FULL PLANNING APPLICATION FOR DEMOLITION OF EXISTING RETAIL UNITS AND PUBLIC CAR PARK AND REDEVELOPMENT FOR RESIDENTIAL DWELLINGS (C3 USE), PROVISION OF PRIVATE CAR PARKING, HARD AND SOFT LANDSCAPING AND PHOTOVOLTAIC (PV) PANELS ON ROOF, AND ASSOCIATED WORKS (REF. 23/01633/F)

ON LAND BETWEEN CALTHORPE STREET AND MARLBOROUGH ROAD, BANBURY

I refer to the consultation response received from Active Travel England (ATE) on 7th August 2023 and write to address the comments raised.

1.1 Pedestrian and Cycle Connectivity

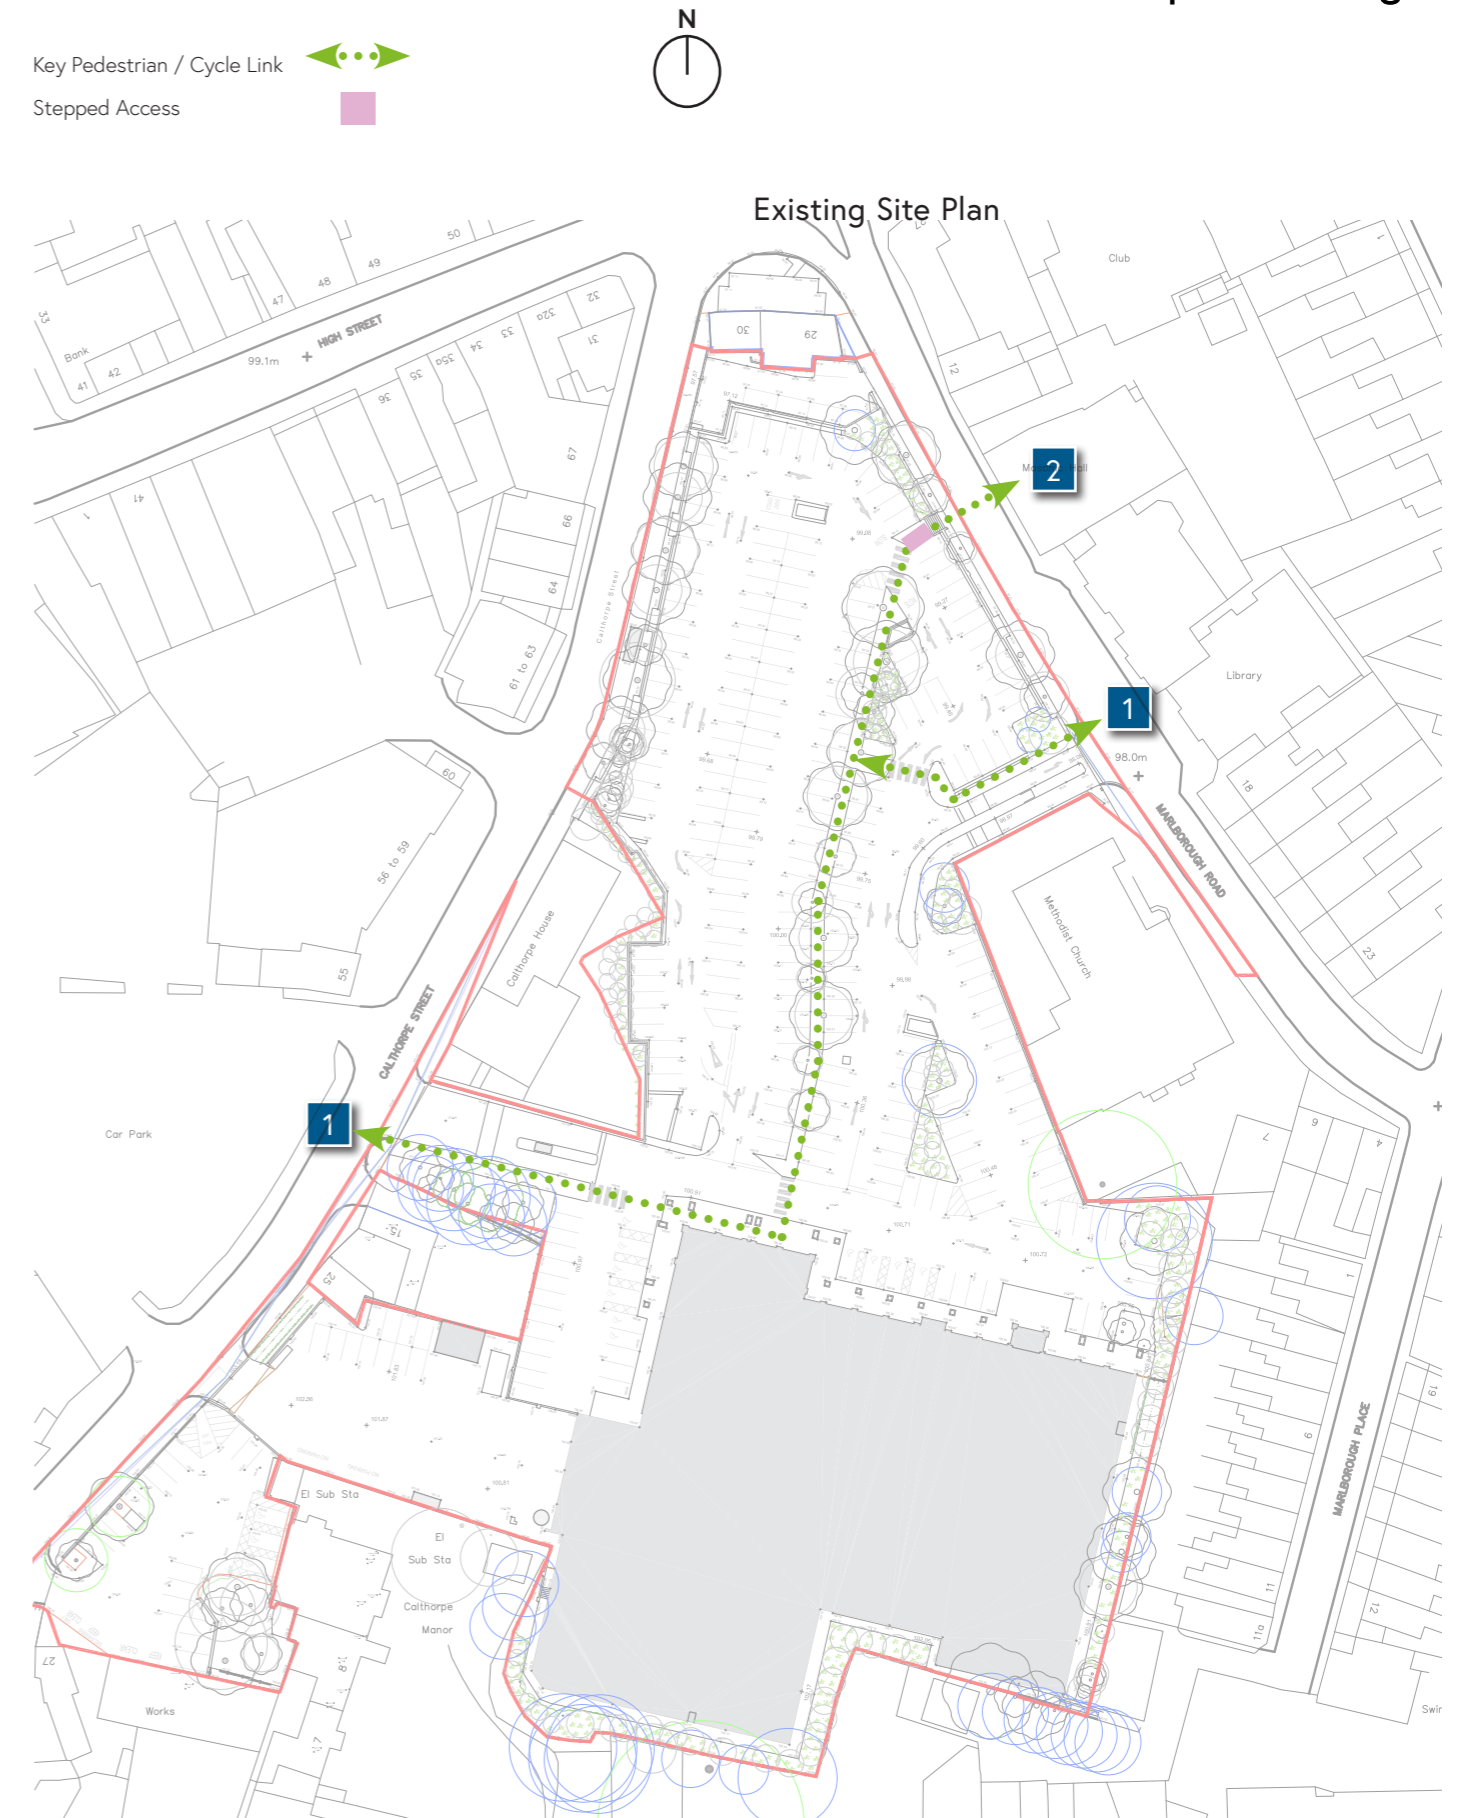
The permeability of the site is welcomed and necessary to encourage walking and cycling. However, it isn't clear whether the southern access onto Calthorpe Road is stepped. It's assumed the access route between Marlborough Road and the northern access onto Calthorpe Road is step-free, but this needs to be clarified. Please provide further clarification of where the steps are. It is stated that there is to be a lift to take people between the landscaped levels in the main north south route through the site. A ramp would be much preferable, as lifts like this are very frequently found out of order.

We welcome OCC's comments on the permeable nature of the proposed design. In consideration of the location non-car access, Corstorphine & Wright have produced an 'LA Highways Comments – Accessibility Report' – enclosed herewith. Section 1.1 (page 4) details five pedestrian / cycle access points proposed across the site – with Point 1 (Smithy Walk, Marlborough Road) and Point 3 (Manor Gardens) provide both pedestrian and cycle access by way of a shared surface access. With this, the shared surfaces measure at least 6-metres in width and afford access to a limited number of parking spaces and therefore vehicular movements (3 spaces from Point 1 and 9 parking spaces from Point 3). As such, both Calthorpe Street and Marlborough Road provide safe and efficient accesses for bicycles.

To provide further clarity, the southern access from Calthorpe Street is provided as a shared surface ramped access up to blocks A, C, and the town houses. Movement south>north from this access is provided by either steps or a platform lift. As per the appended report, it is considered that the continuous operation of the lift can be guaranteed via a suitably worded condition.

Lower Ground Floor Site Plan

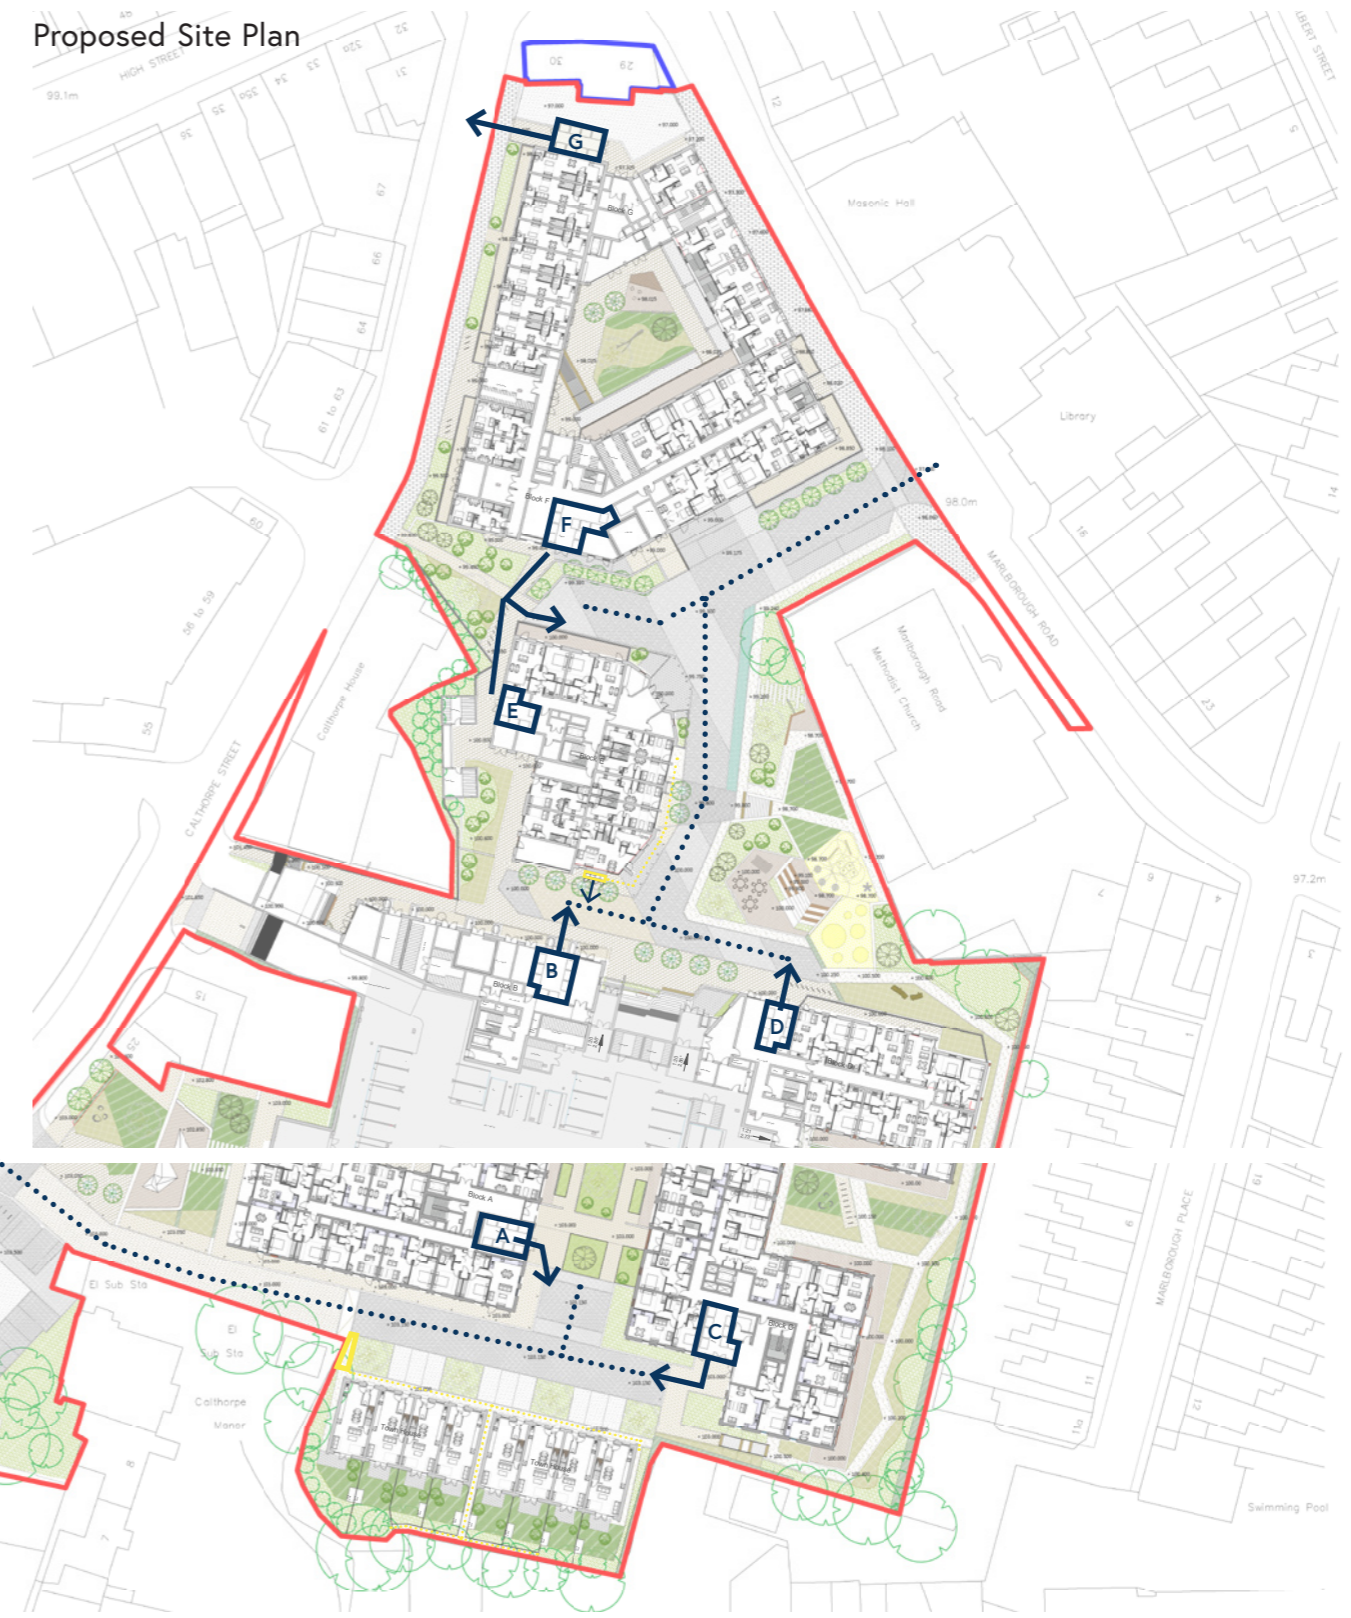
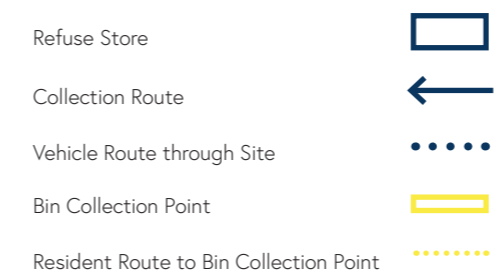
Refuse collection would be from within the development, however bin stores are not labelled on the floor plans.

We have sought to clarify both the refuse and delivery stores and routes in response to the above comments from OCC. With this Corstorphine & Wright have included detailed plans showing refuse and delivery accessibility routes to the respective stores and building entrances across the site within the appended report. For confirmation, all refuse stores and main entrances for deliveries can be accessed step free and do not require use of the external lift proposed within the site.

Proposed Site Plan

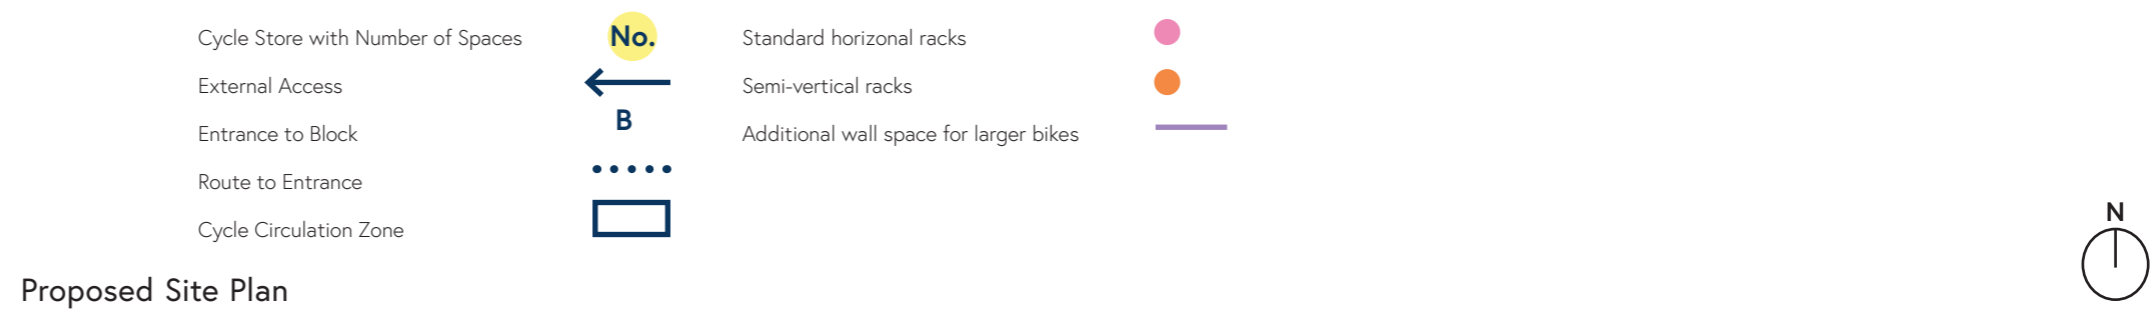
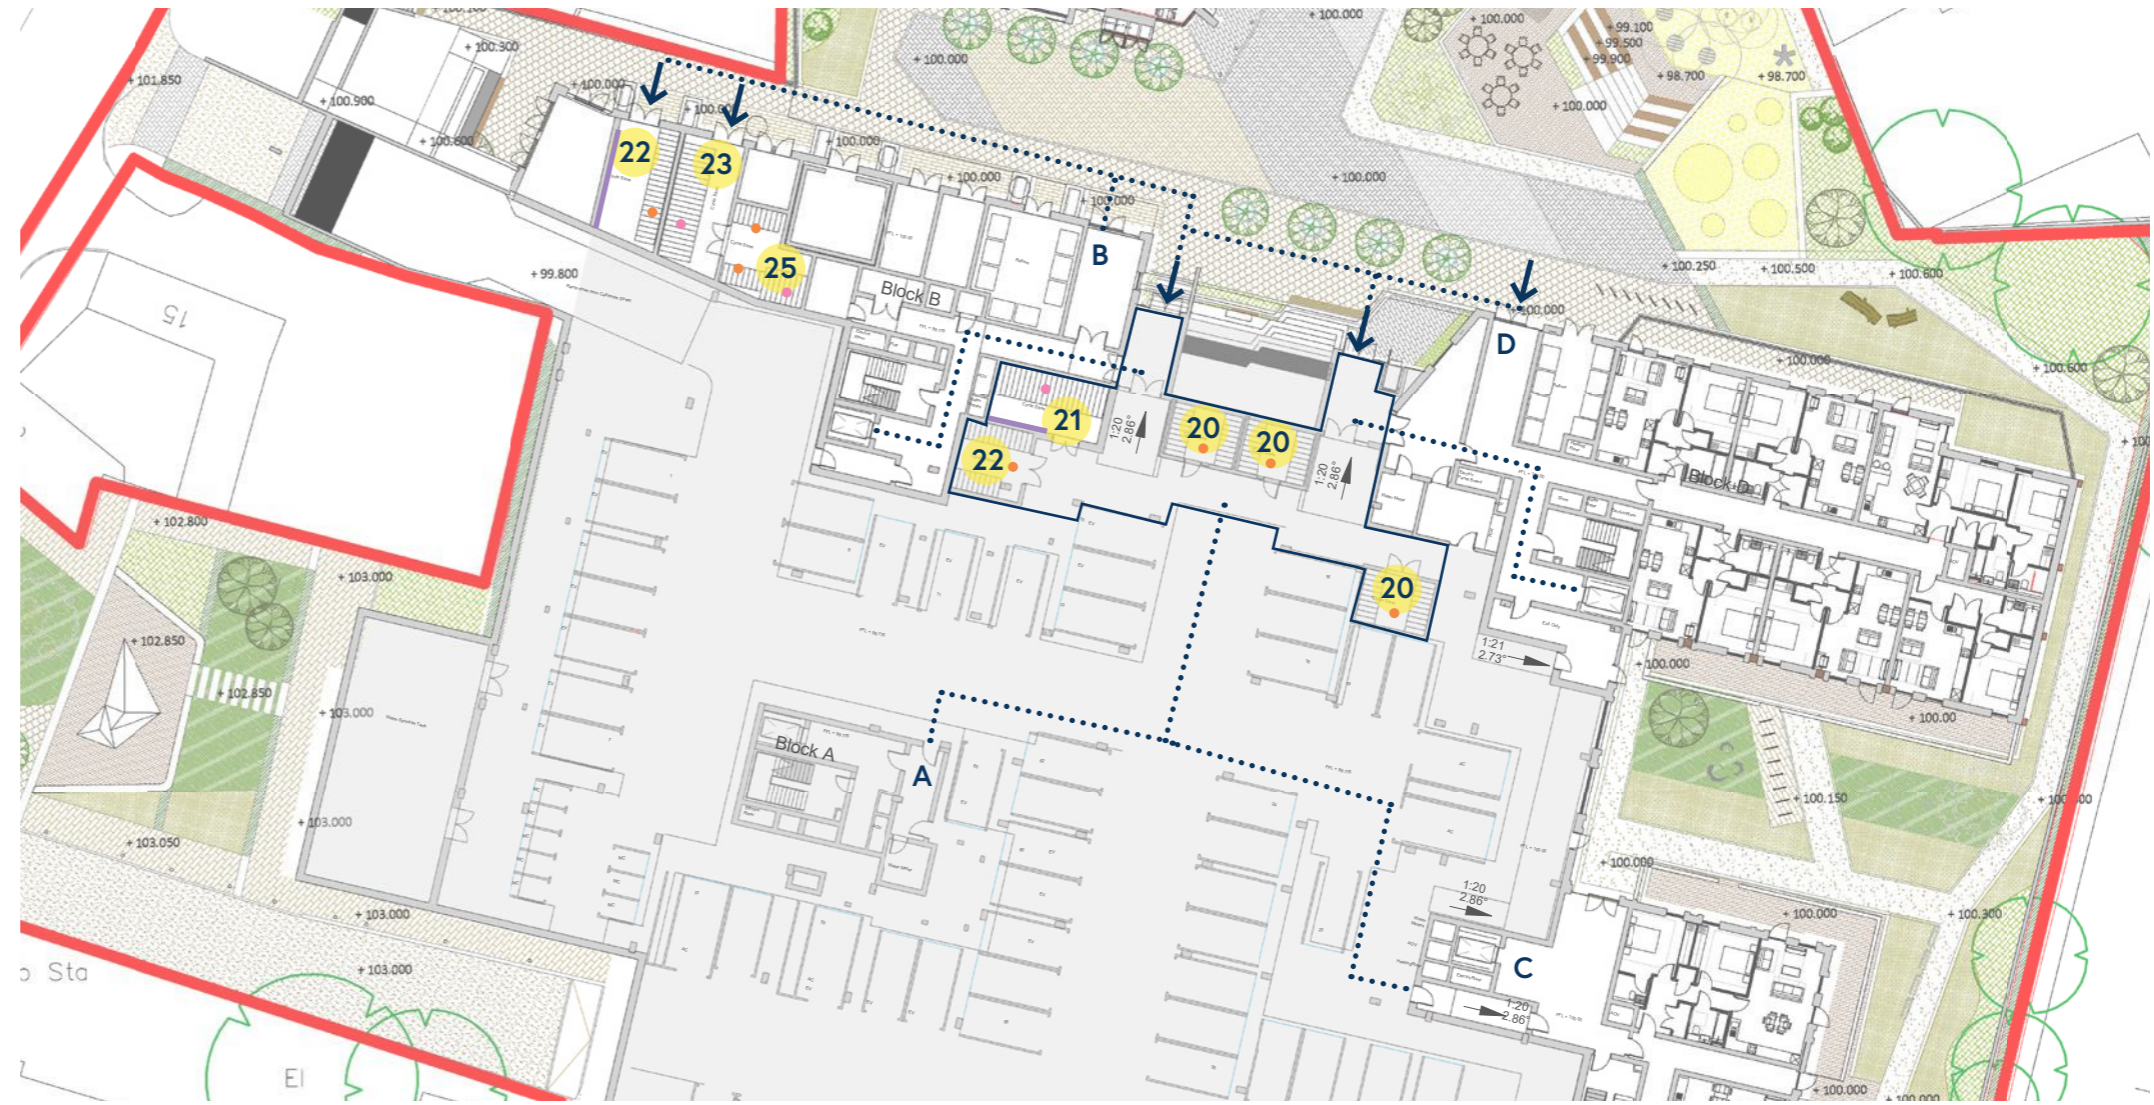
"A number of cycle stores are provided throughout the site, although their location is not clear from the floor plans, on which they are not labelled. Further detail is required to understand exactly where these stores are, how they are accessed, and the type of cycle parking within them. The OCC Parking Standards state that cycle parking should be provided in a convenient location close to building entrances and that the parking should be in the style of a Sheffield stand, not double-decked or vertical unless agreed by OCC in special circumstances."

"Each cycle parking store should provide for e-bike charging."

Following the comments, we have sought to produce plans to clarify the position of cycle stores across the site. With this, Section 1.4 of the appended Corstorphine & Wright Accessibility Report details all proposed locations – with cycle stores conveniently located; close to the building entrances and being directly accessible from outside.

With regards to the design of the cycle parking, the proposals have been amended to provide a mixture of horizontal and semi-vertical racks (91 horizontal and 197 semi-vertical racks), both types of parking available to each residential block. The semi-vertical racks can be provided with electric charging points and as such, each block will be afforded access to electric bike charging spaces.

Cycle Hire Lockers

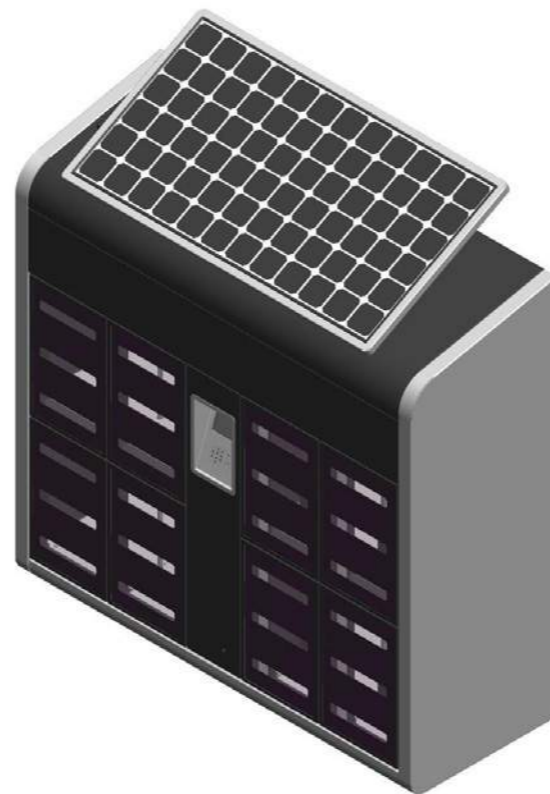
Banbury Rail Station Cycle Infrastructure - There are currently 63 cycle spaces at Banbury Station, and considering this is likely to be cycled to by residents of the proposed development, a financial contribution towards infrastructure should be considered, such as increasing size and improving the infrastructure available at the station.

A better of way dealing with this would be to provide a form of on demand cycle provision, such as, a Brompton bike hire vending machine. This would avoid the need to provide cycle parking for the infrequent and mostly leisure-based trip purposes. This was discussed at the meeting with OCC (dated 23rd August 2023), where there was broad agreement. This has now been discussed with the applicant, with agreement to provide the Brompton machine in the centralised and highly visible location shown within Section 1.5 of the appended Accessibility Report.

As suggested by OCC, the Travel Plan Coordinator will monitor demand via Brompton's usage statistics – which are recorded at each locker location. As such, the requirement for further spaces can be determined. Alongside this, OCC requested that we identify the potential locations for an additional locker within the site. In this way, Section 1.5 (page 12) of the appended report outlines an additional location within the centre of the site.
